ADA Site Review and Comments

Project: **Chinsegut Hill Retreat**
22495 Chinsegut Hill Rd, Brooksville, FL 34601

Summary: **Accessible path slopes/surfaces, accessible parking space, ramps slope, emergency egress accessibility**

Figure 6: Proposed Accessible Parking Location

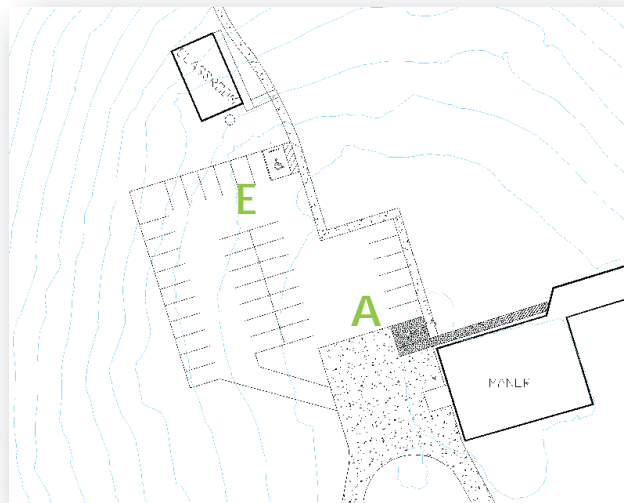
Only 1 of the 2 required accessible spaces are provided based on available parking spaces. While the parking spaces are not delineated in the grass parking area, it is understood these areas are routinely parked for events based on perimeter provided.

Possible Solution: Provide an additional ADA parking space in parking area 'E' near the entrance to the retreat area. Alternately, the space may be located next to the existing parking space 'A', or if vehicles are permitted or desired in the retreat area, near the accessible cabin 'K' or at the entry to Dining Hall 'Q'. If no other vehicles are permitted in the Retreat area during retreats, location E is the most compliant area.

Figure 7: Proposed Accessible Space Plan Location 'E'

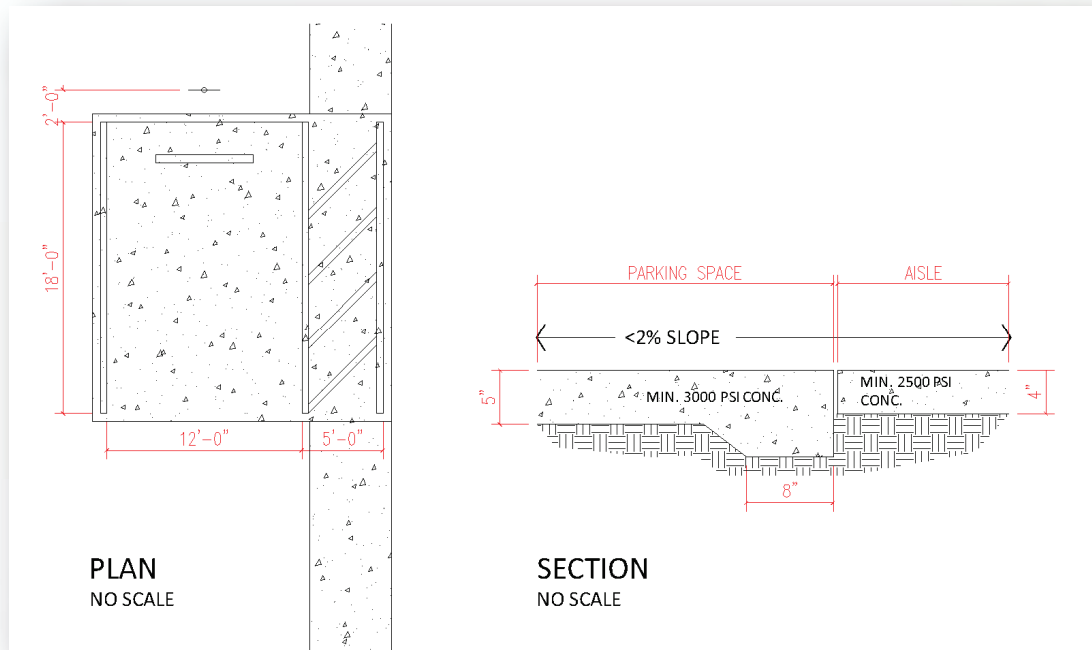
Accessible parking spaces shall be paved (3000 psi concrete, 5" min. thickness is recommended on compacted soil) 12'-0" min. in width and 18'-0" in length designated with a 4" blue painted line on each side of the space with a 5'-0" wide aisle marked with 4" diagonal lines. Aisle and sidewalks shall be 4" thick concrete at a min. of 2500 psi. Spaces shall be marked with an accessible parking sign with violation notice meeting the state statues. (Figures 7 & 8)

Figure 11: Hernando County Accessible Parking Standards for Locations A & E

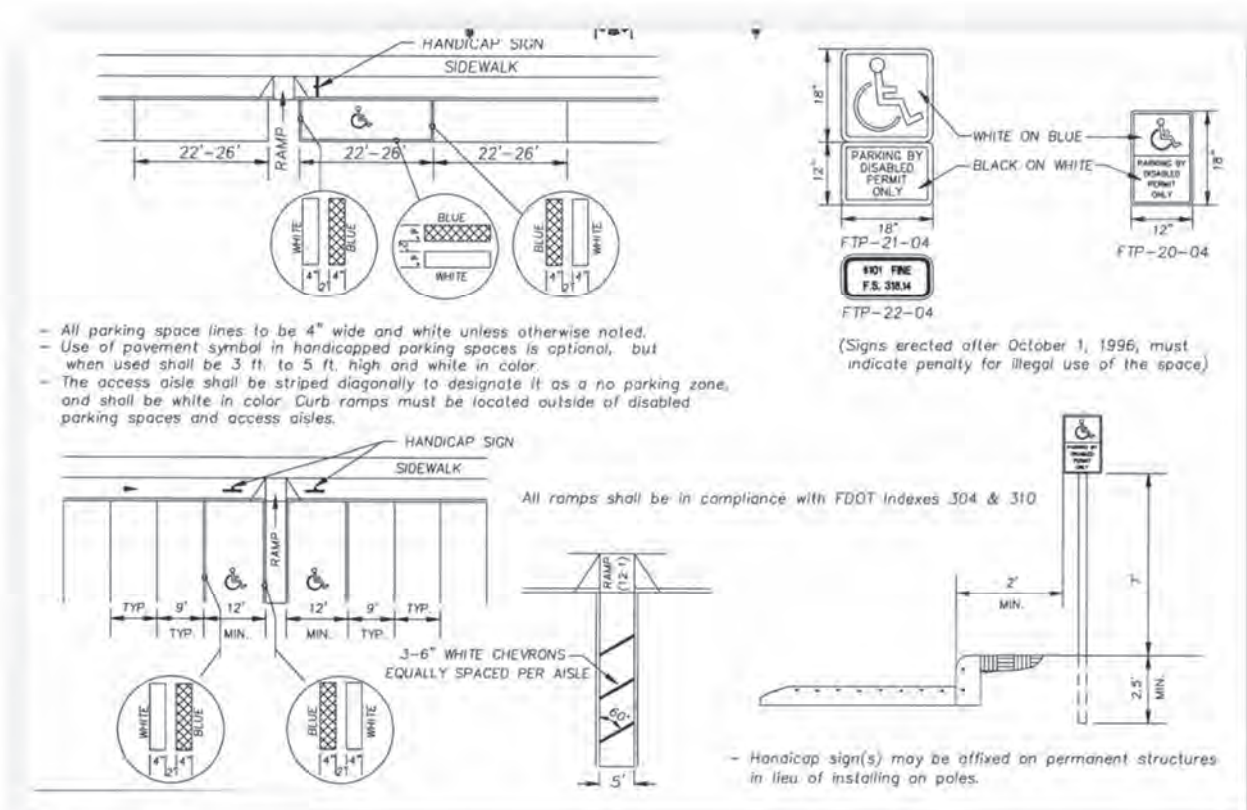
✘ Pole Signage: **Improper Height: 53"** (<84" & >60" Abv Grade - FAC 502.6.1)
Improper Type: Missing Penalty and Statue # (International symbol of accessibility and the caption "PARKING BY DISABLED PERMIT ONLY." Such a sign, erected after October 1, 1996, must indicate the penalty for illegal use of the space and state statute #. Face of sign to be located 24" min. from face of curb.

Possible Solution: Remount existing sign to taller pole so bottom of sign is placed between 60" and 84" above grade. Consider adding required parking striping to comply with Hernando County Standards. (Figure 11)

Figure 26: Accessible Restroom

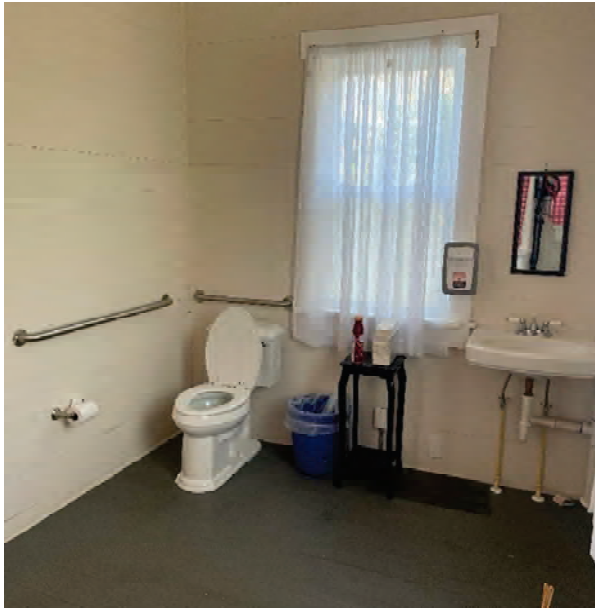
C: Accessible Restroom: An accessible restroom is located in the office/foyer space at the top of the accessible ramp at the Main House (C) (Figure 26)

- ✘** Water Closet Height: 17.5" (19" Required) (Figure 27)
- +** Side Clearance: 18" (18" required) (Figure 28)
Flush Lever on Room Site: Yes
Lavatory Depth: 21" (19" required) (Figure 31)
Controls: Levers are Historic (Exempt)
Height: 33" (32" – 34" Required) (Figure 33)
- ✘** Lavatory Side Clearance: 4" (6" required) (Figure 32)
Scald Protection: Missing (Figure 34)
- +** Door Clearance: Push 23" (12" Required) Pull 18.5" (18" Required 24" Preferred)
Door Signage: Sign at 54" AFF w./ Brail (Figures 35-36)
- ✘** Grab Bars: 24" Rear 48" Side (36" Rear and 48" Side) (Figures 29, 30)
35" High (34" – 36" Allowed) (Figure 26)
(Historic Exception Allowed for Window)

The only change possible in this space is to **install scald protection on the piping under the sink.**

Figure 50: Threshold

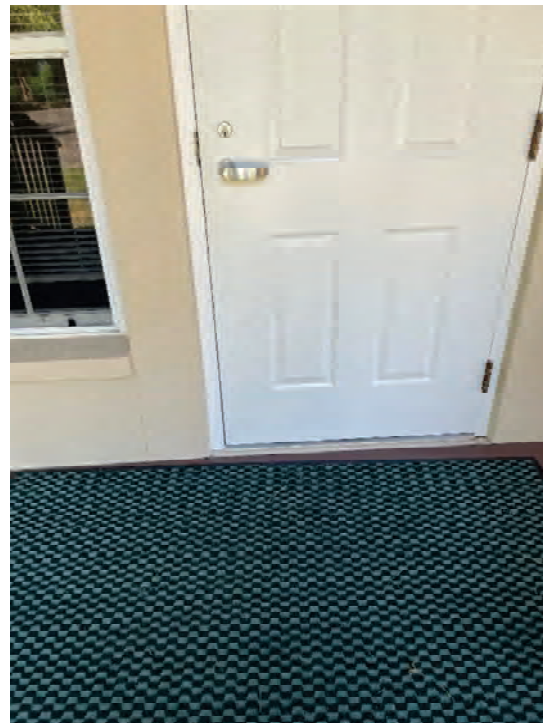
- +** Width: 40.5" (Min. 36" Width Required) Building has an estimated occupant load of 6 negating the 44" egress requirement.
 Length: 12'-6" (Max. 30' allowed)
- ×** Slopes: <2% Cross Slope & 9.4% Running Slope (Max. <2% Cross Slope and <8% Running Slope allowed)
- +** Landing: 60" x 60" <2% Slope (60" x 60" @ <2% Slope Allowed)
- ×** Guardrail: 38.25" (Min. 42" Required)
 Picket Spacing: 4-5/8" (4" Max. allowed)
 Handrail Dia: Non-Compliant Design (1.5" Dia. required FAC 505.6)
 Handrail Extension: 4" (12" min. Required FAC 505.10)
 Handrail Clear: Non-Compliant Design (1.5" min. clearance required FAC 505.5)
- +** Threshold: .25" change in elevation (.5" allowed with a .5" bevel otherwise .25" maximum allowed FAC 303.2) (*Figure 50*)

Figure 59: Accessible Path L-N

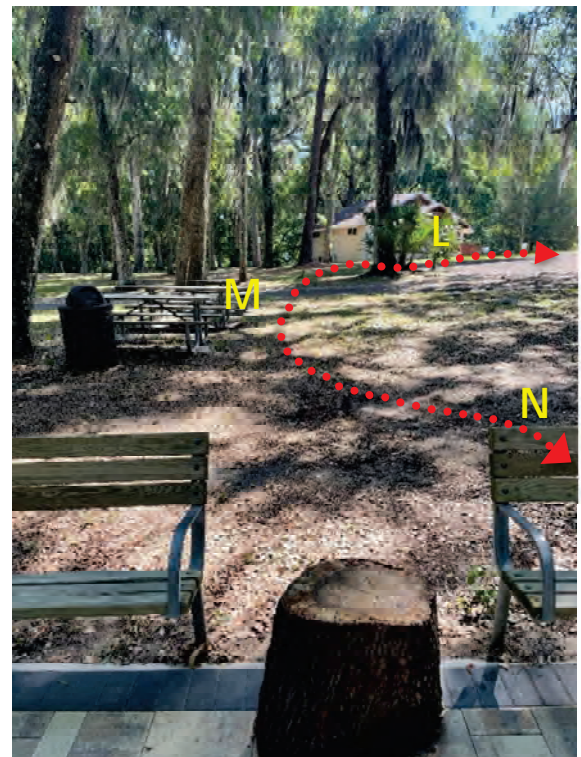
H-Q Accessible Path: No Accessible Path exists connecting public spaces on the site to include the Manor House (B), Parking Area (A&E), Classroom Cottage 2 (K), Fire Pit (O) and Dining Hall (Q). Excluded from this requirement are cottages 4-7 which are not required to be on an accessible route as these are not accessible lodging. (Figure 63)

Slopes: A-E: <2% Slope in the direction of travel
 E-H: 3%-7% Slope in the direction of travel. (Requires arc in sidewalk path to reduce slope to <5%).
 H-K: 4% Slope in the direction of travel
 L-M-N: 4% Slope in the direction of travel
 N-P-Q: 5% Slope in the direction of travel. (Requires arc in sidewalk path to reduce slope to <5%).

Possible Solution: Install a 5'-0" wide concrete sidewalk (min. 4" thick @ 2500 psi with control joints in 5'-0" increments) from the Manor House to Dining Hall (connecting points A, D, E, G, H, K, O and Q). Potential path indicated in (Figures 56-57). Path shall be no greater than 5% in slope in the direction of travel with a maximum 2% cross slope which is possible in

the general path shown in Figure 6. The sidewalk can be curved to fit with the dynamics of the land, reduce slope to less than 5%. prevent abrupt changes in direction requiring landings and avoid trees and tree roots. (Figures 57-61, 63)

Figure 63: Accessible Path A-Q

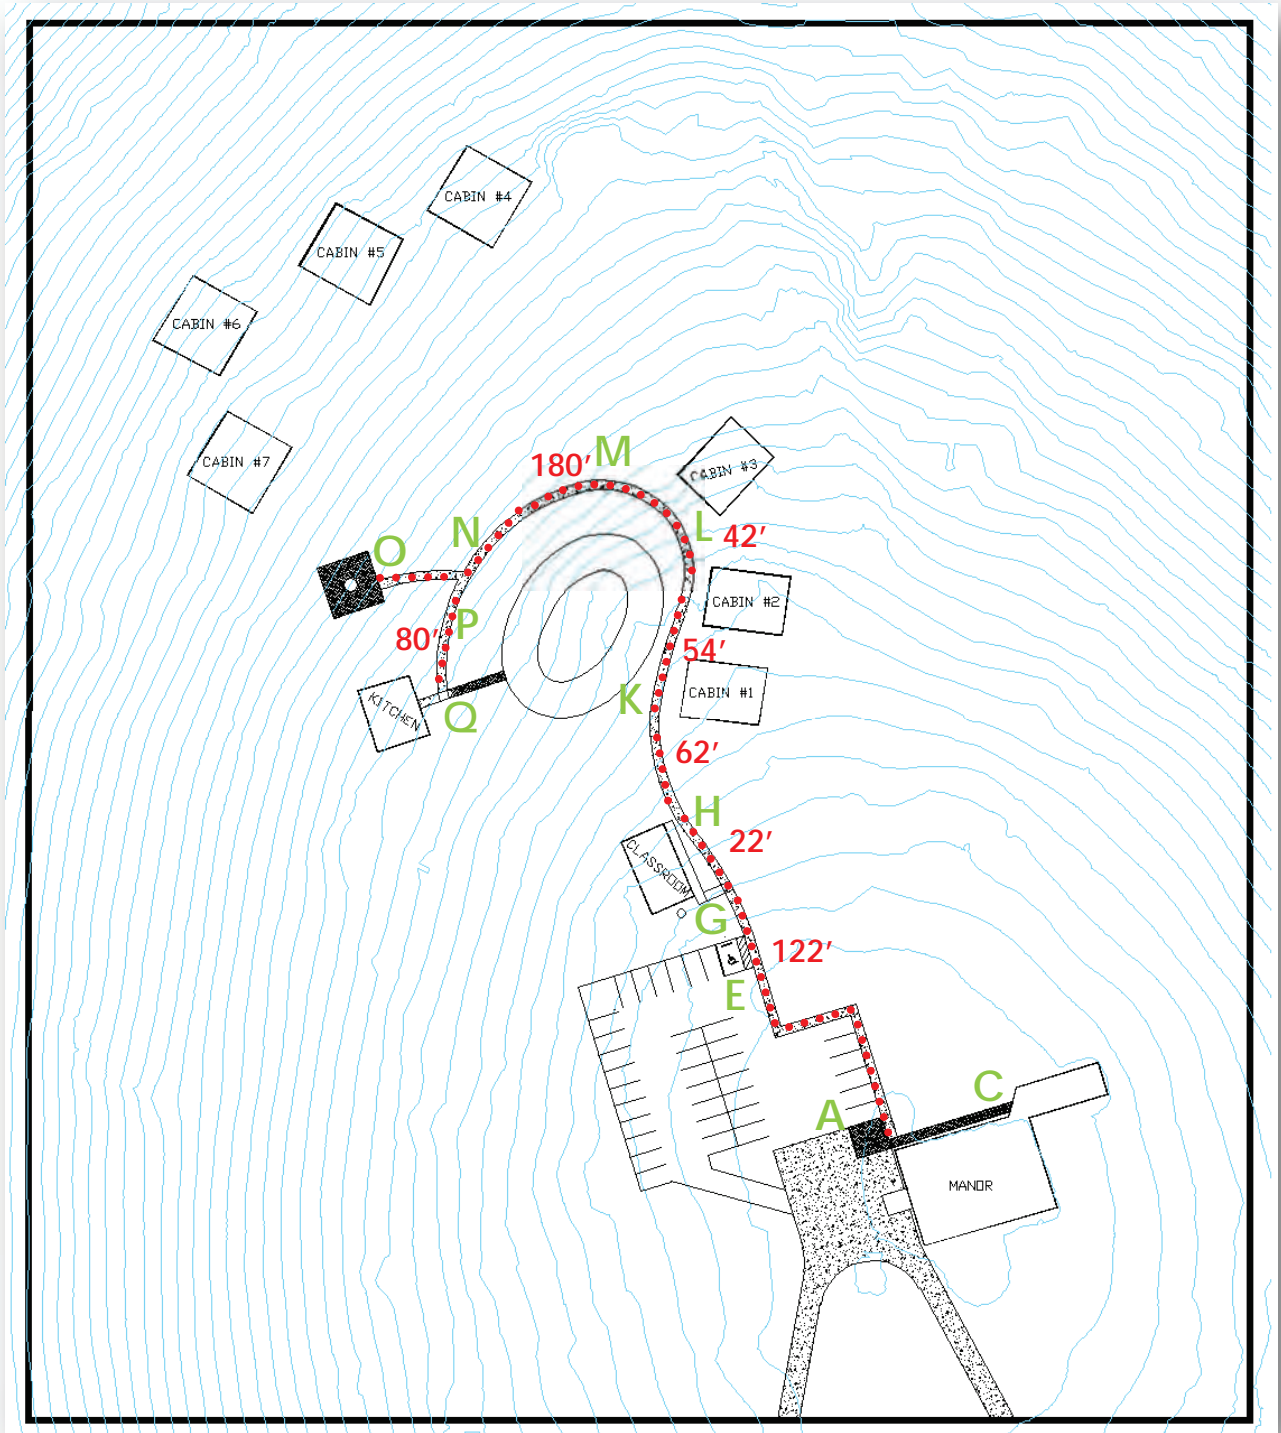
An accessible path is required to have minimum lighting at the exterior of 0.2 Foot Candle (2.15 Lux) at the walking surface. (FBC 1008.2.1 Exception 2). Steps, landings and the sides of ramps shall be permitted to be marked with self-luminous materials in accordance with Sections 1025.2.1, 1025.2.2 and 1025.2.4 by systems listed in accordance with UL 1994. The exterior accessible path, building ramps, porches and landings were not observed in low natural lighting conditions with the exterior lighting fixtures on. It is recommended that the lighting levels be measured at the walking surfaces of the accessible path. *(Figure 63)*

If lighting levels at the exterior accessible path measure less than 0.2 Foot Candle (2.15 Lux), install full-cut-off lighting fixtures intermittently to provide minimum lighting levels. Note, fixtures can be specified which are motion activated, solar powered with batteries which are ideal for commercial applications and can be mounted to poles. An electrical engineer is recommended for this phase of work.
